Recall Bulletin

PRODUCT EMISSION RECALL

SUBJECT: Oxygen Sensor Fracture

MODELS: 2011-2013 Chevrolet Express
2011-2013 GMC Savana
Cutaway Equipped with Gasoline or Liquefied Petroleum Gas (LPG) Fuel Engines

First and Second Design Sensors

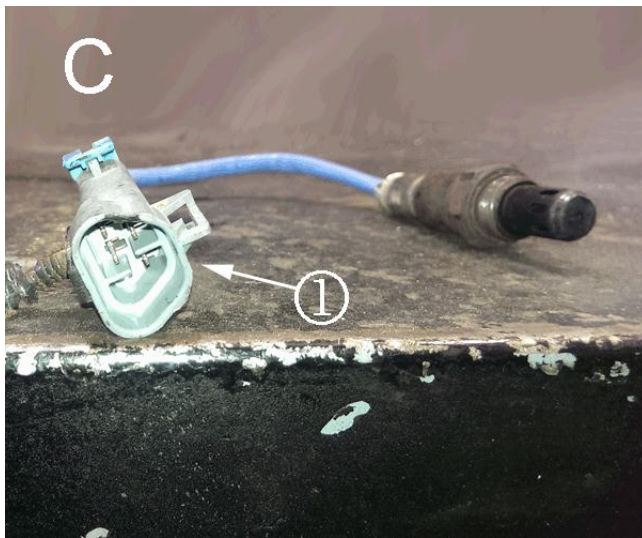
(A) 2011 through early 2013 OE production first design male connector. Replace the part with a second design part with a male connector, P/N 12637297. (B) 2011 through 2013 second design service part, P/N12637297. Do NOT replace this part unless the part has failed. If the part has failed, replace the part with the second design part with a male connector, P/N 12637297.

(C) This is the second design 2013 production sensor with the female plug (1). The sensor and plug change was made to indicate the new design. Do NOT replace this sensor, P/N12656071, unless the part has failed.

3. Determine if a first design (A) or second design (B) heated oxygen sensor is installed using a light and mirror.
 - If a second design (B), P/N 12637297, P/N 12656071 heated oxygen sensor is currently installed, no further action is required. Lower the vehicle. Refer to *Lifting and Jacking the Vehicle* in SI.
 - If a first design (A), P/N 12612571, heated oxygen sensor is in place, remove the sensor and replace it with a second design heated oxygen sensor. Refer to *Heated Oxygen Sensor Replacement –Bank 2 Sensor 2* in SI and *Heated Oxygen Sensor Replacement –Bank 1 Sensor 2* in SI.
